UZBEKISTAN GAS TO LIQUID PROJECT (UZGTL)

HAZOP ACTION CLOSE-OUT REGISTER FOR MAKE-UP H2 COMPRESSOR PACKAGE

UZGTL-HDC-HSE-RP-50-0-0004

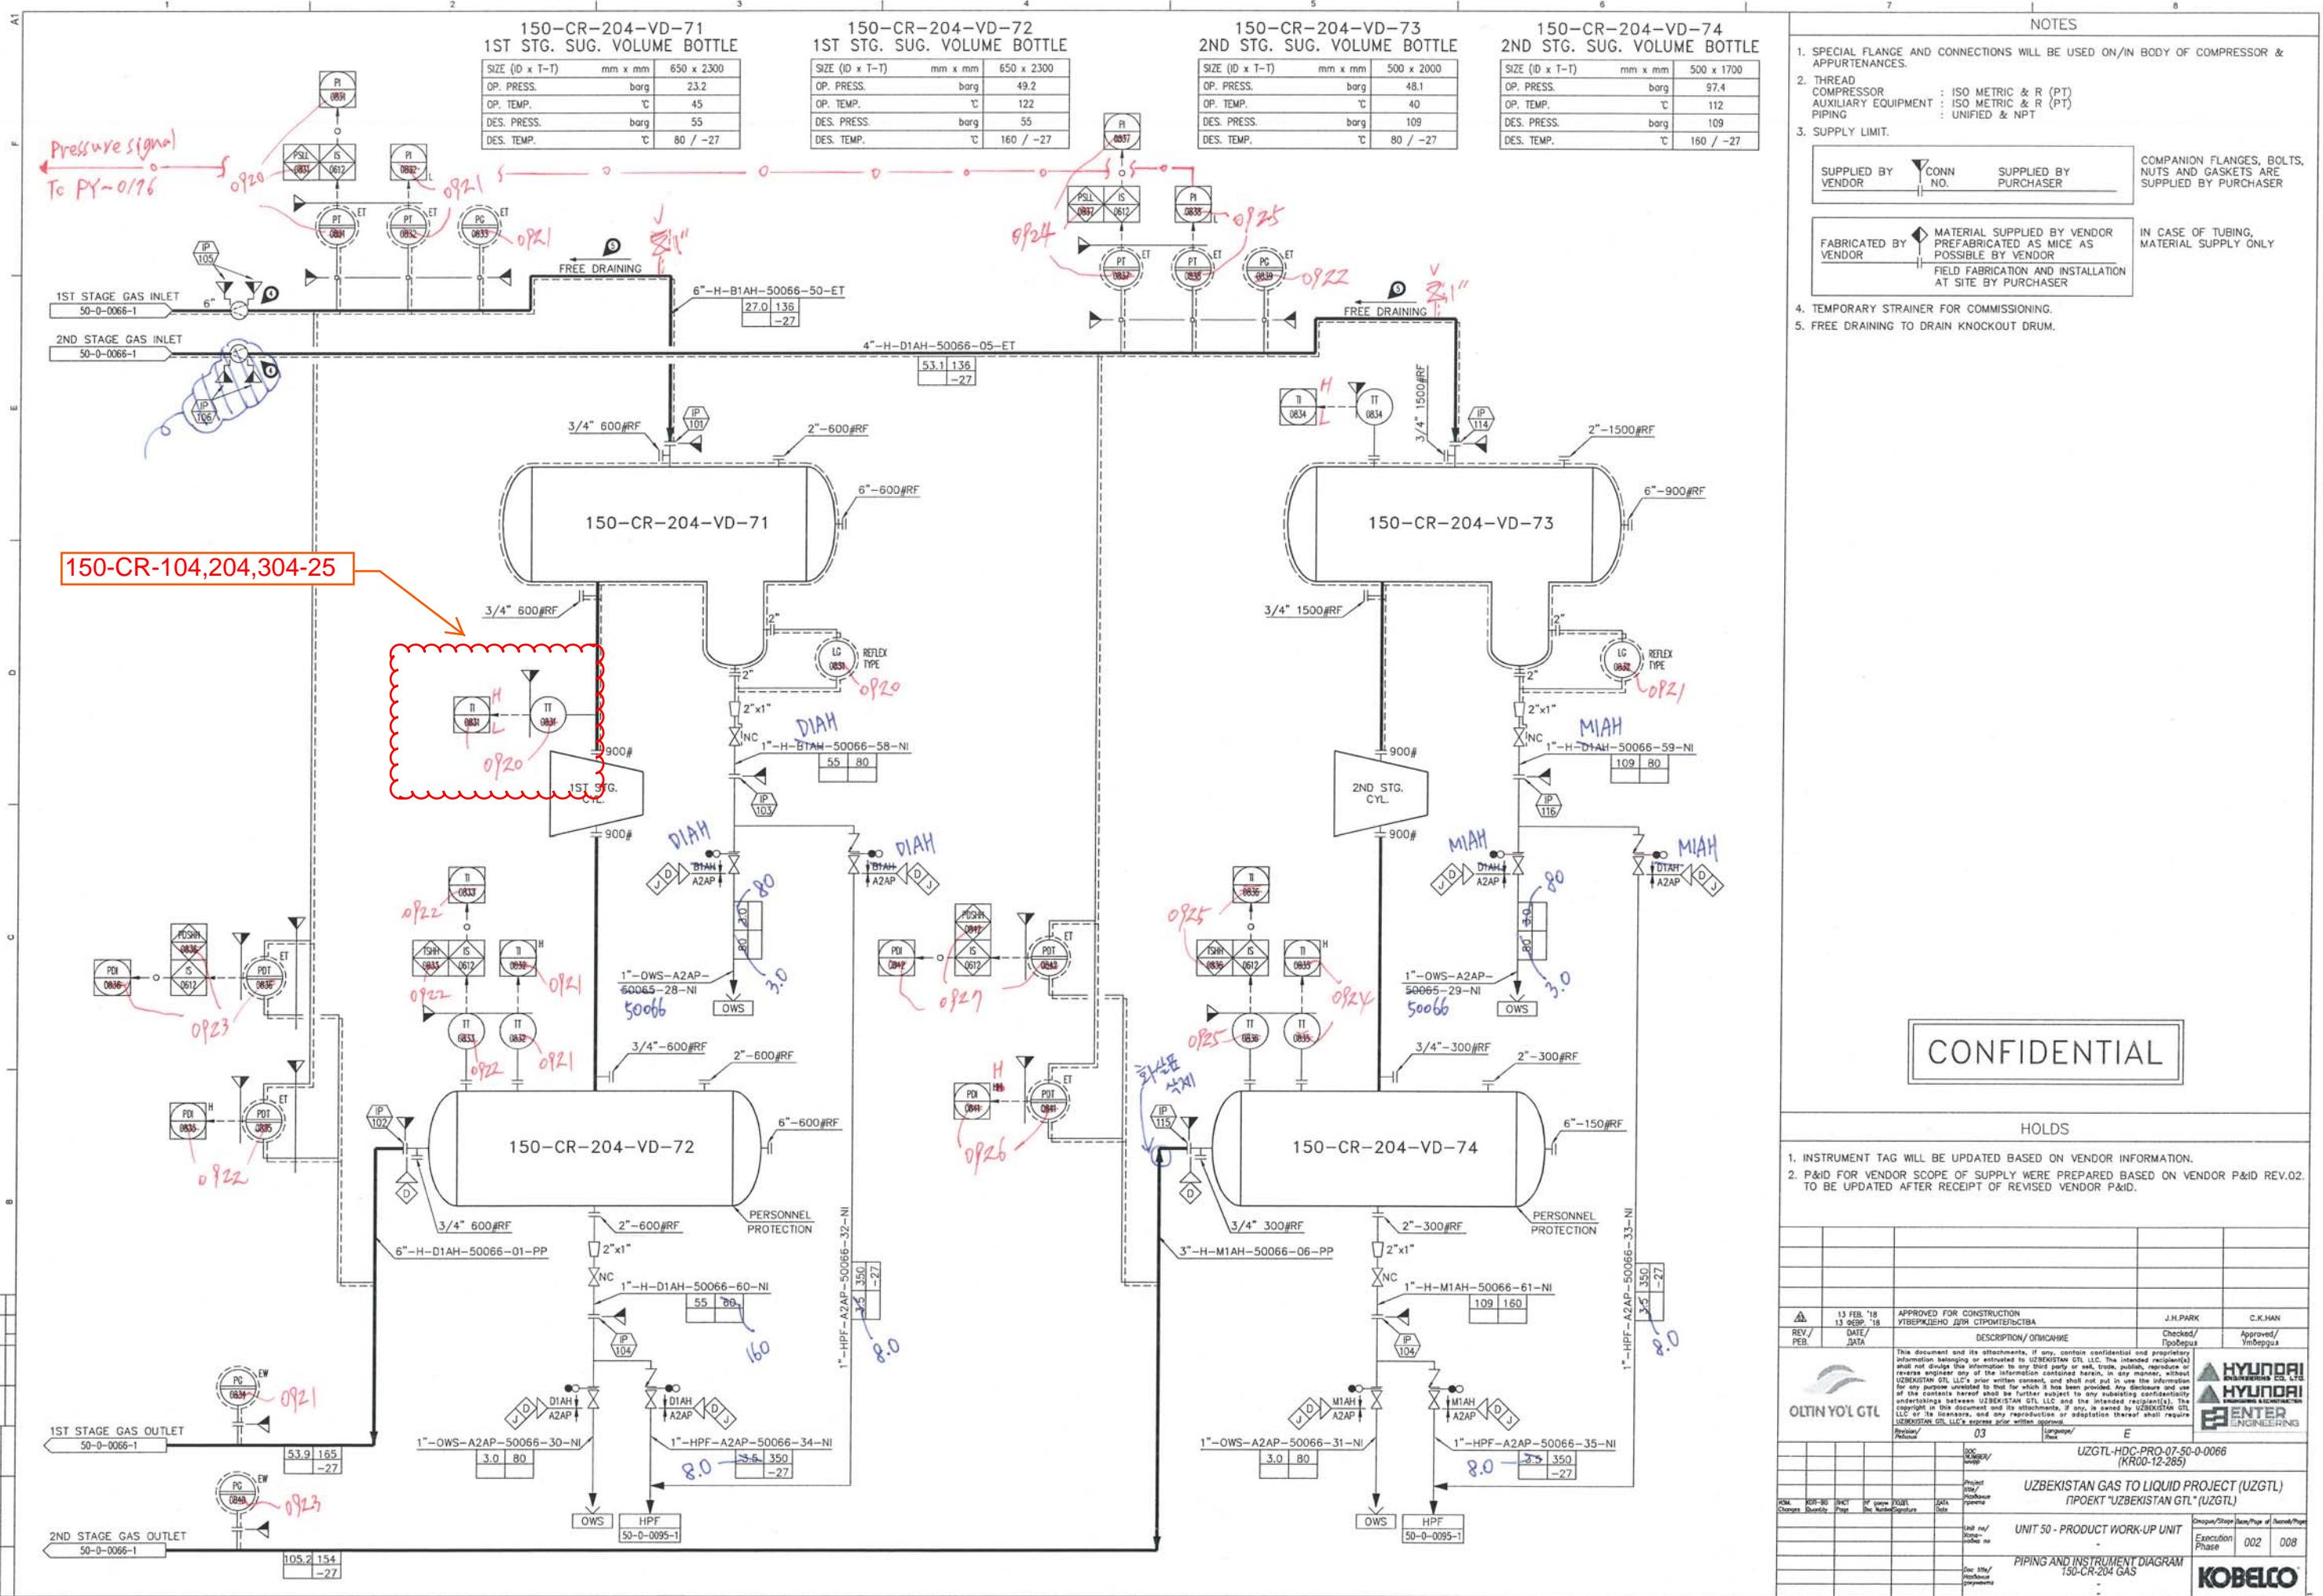
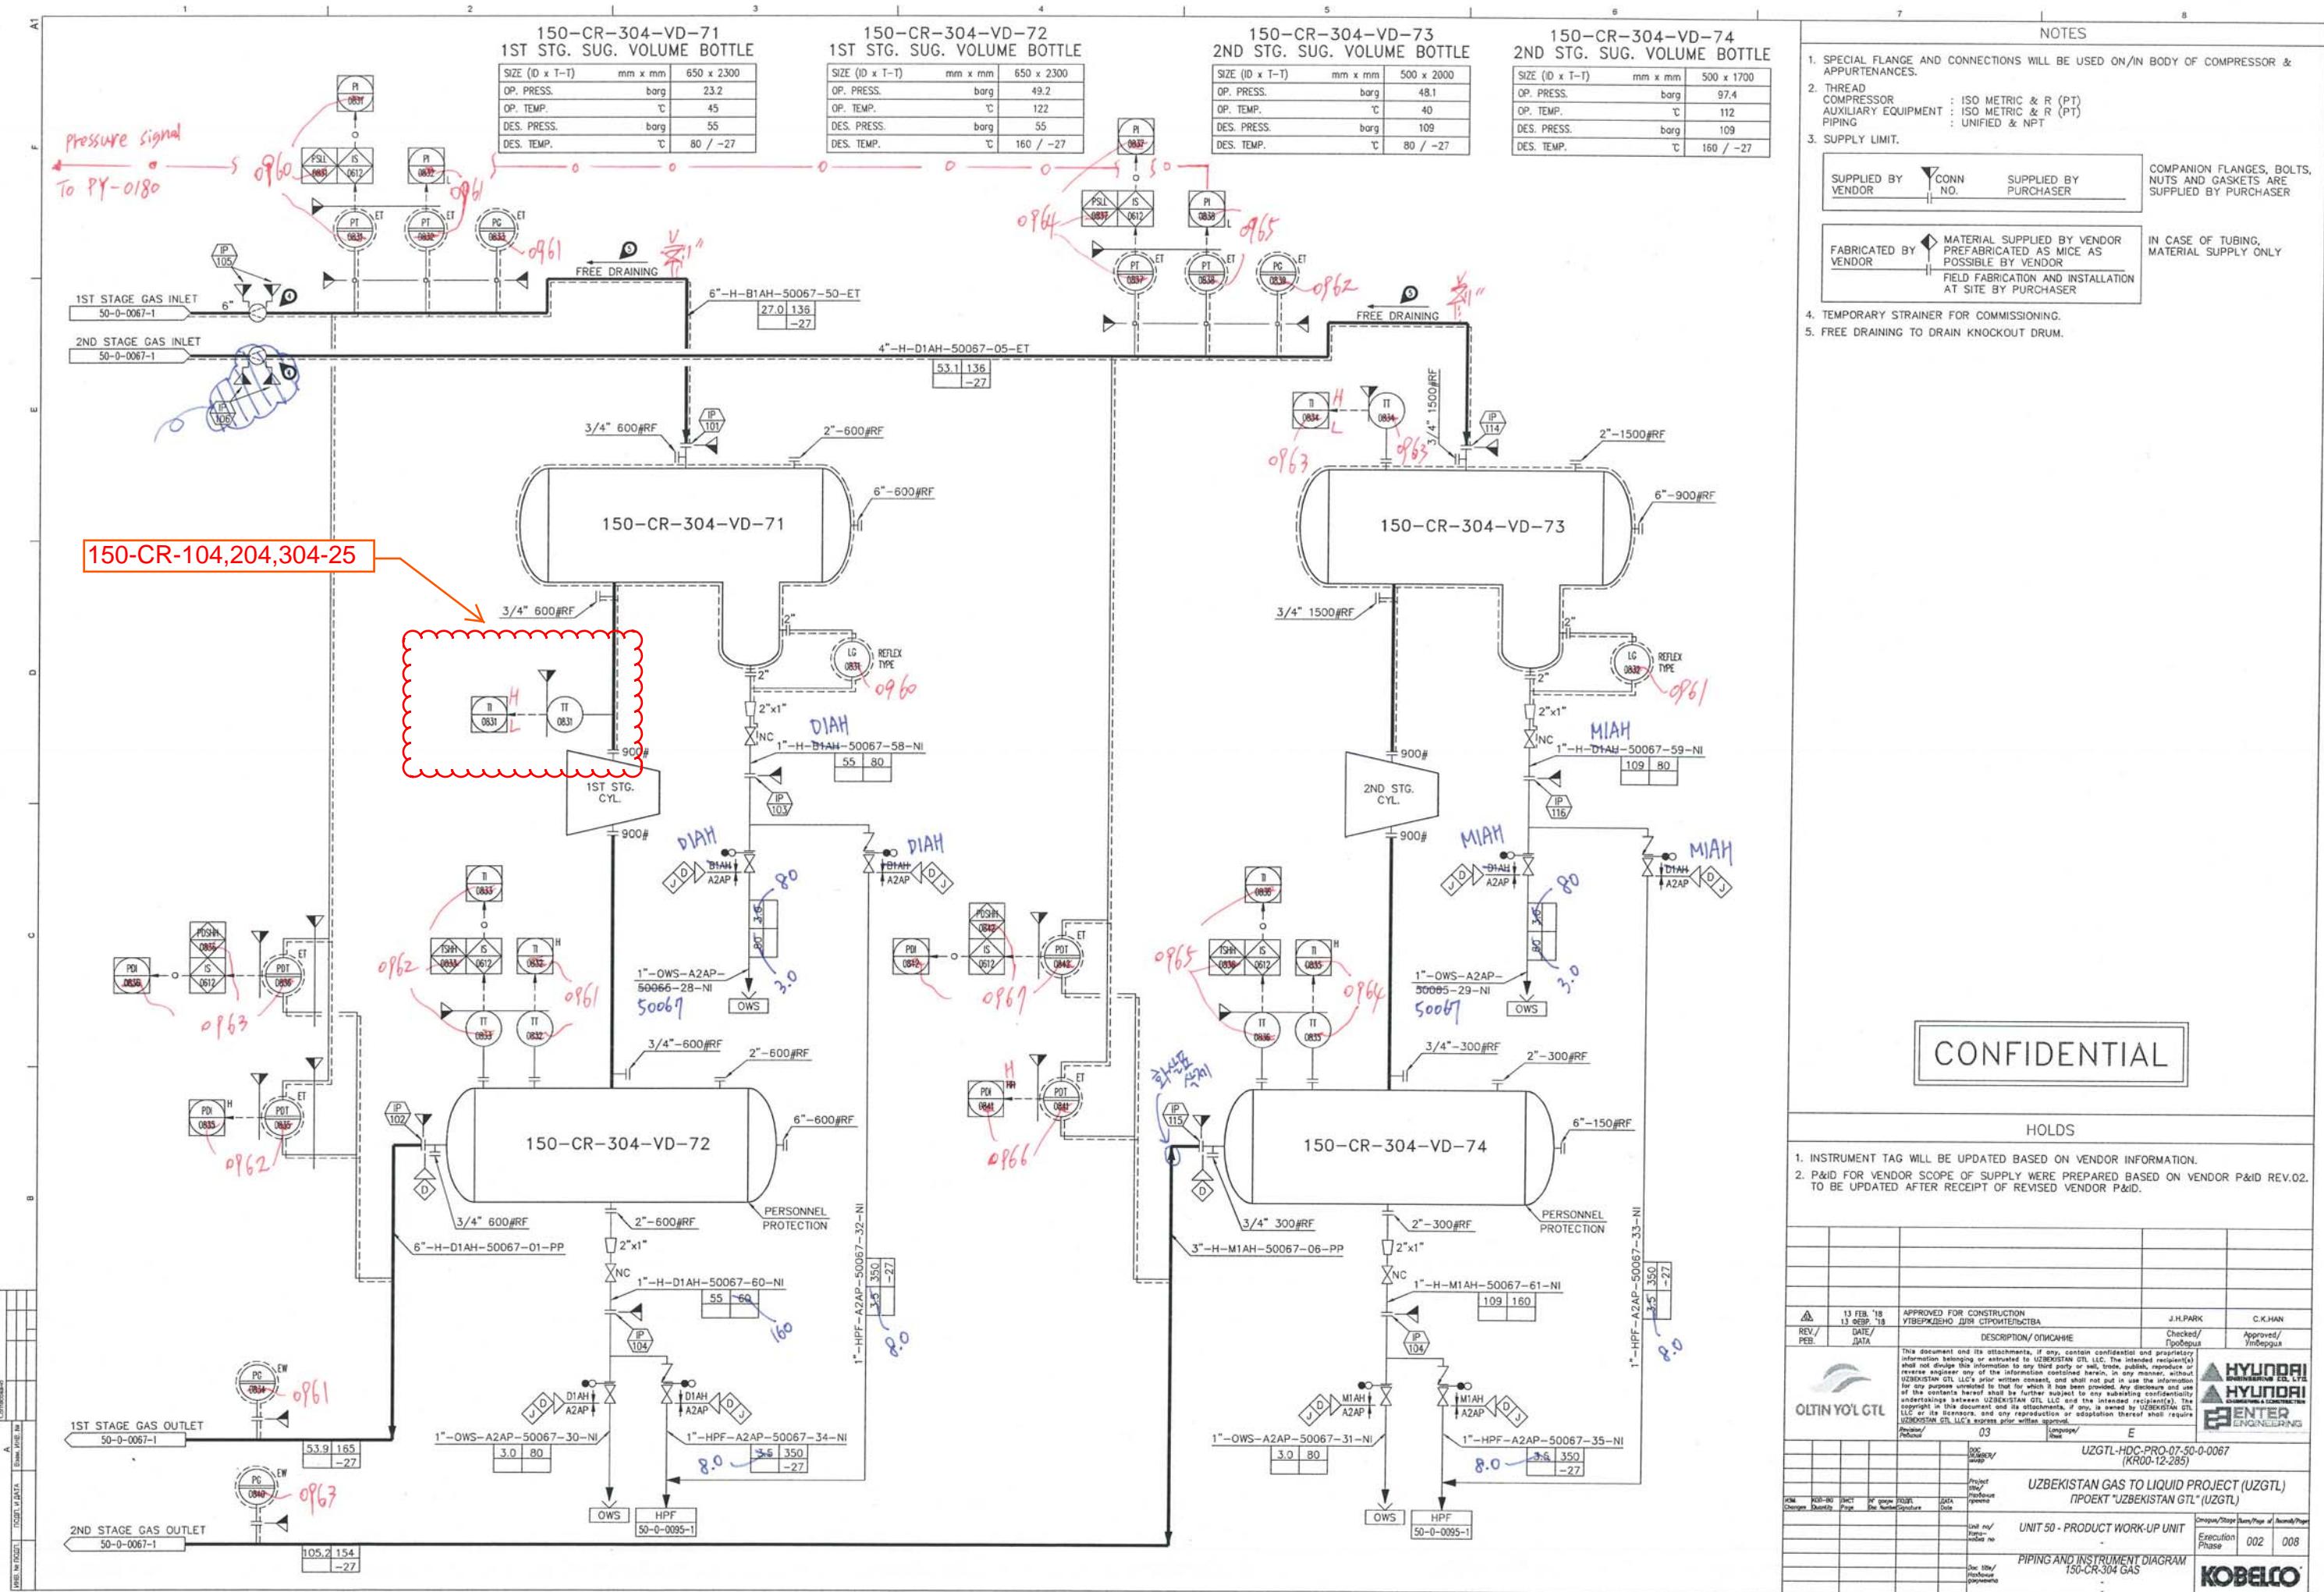
Action No.	150-CR-104/204/304-30				
Action By	PR				
Node No.	1				
Node Description	1. Compressor Process Gas / Compressor Vent & Drain / Compressor Unloader				
Cause	1.17.3. Compressor capacity load control malfunction during start-up with N2 run				
Consequence	1.17.3.2. In case of incorrect line up, potential overpressure could affect upstream piping and equipment				
Safeguards	1.17.3.2.1. 150-PCV-0284 (Pressure regulator on N2 line)				
Action	Provide check valve on H2 make-up line from Unit 60 (downstream isolation valve at BL)				
Response	Since the dissimilar type double check valves are installed on the H2 make-up line of Unit 60 (60-0-0012-1), the check valve will not be installed on the H2 make-up line of unit 50 line.				
CONTRACTOR			OWNER		
Position	Signature	Date	Position	Signature	Date
Process Engineer	<u>B.M.Hwang</u> 	10-Apr-2018		_____
